| | UNITED STATE EPARTMENT OF THE I UREAU OF LAND MANA | NTERIOR . | i i | OMB N | APPROVED NO. 1004-0135 : July 31, 2010 |
|--|--|---|--|---|--|
| SUNDRY NOTICES AND REPORTS ON WELLS Do not use this form for proposals to drill or to re-epter an ARTESIA abandoned well. Use form 3160-3 (APD) for such proposals, ARTESIA | | | | 5. Lease Serial No. NMNM1015856. If Indian, Allottee or Tribe Name | |
| 1. Type of Well 🚺 Gas Well 🔲 Ot | her | | 8. Well Name and No. LUCKY STRIKE AST FEDERAL COM 1 | | |

Lucky Strike AST Federal Com 1 30-015-30765 Yates Petroleum Corporation April 12, 2013 Conditions of Approval

Date: 1/18/13 Lucky Strike#1b

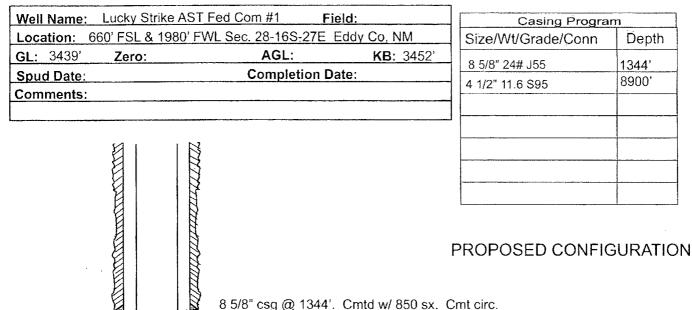
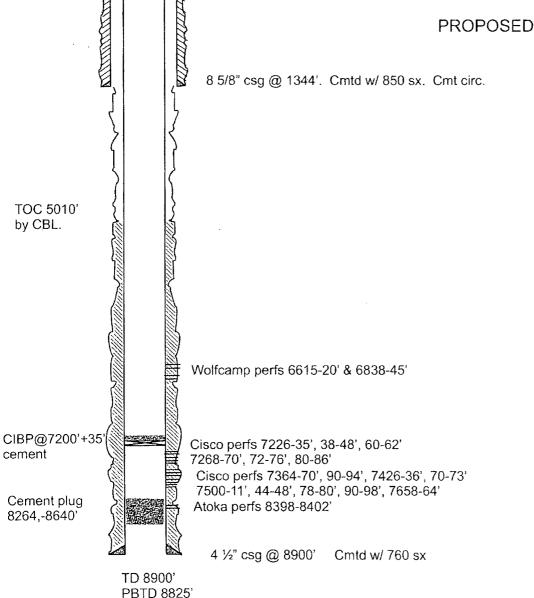
- 5. The operator shall set a CIBP at 7176' (50' above the current perforations). Tag CIBP at 7176'. Dump bail 35' of neat class C cement on top.
- 6. All waste (i.e. drilling fluids, trash, salts, chemicals, sewage, gray water, etc.) created as a result of work over operations shall be safely contained and disposed of properly at a waste disposal facility. No waste material or fluid shall be disposed of on the well location or surrounding area. Porto-johns and trash containers will be on-location during fracturing operations or any other crew-intensive operations.
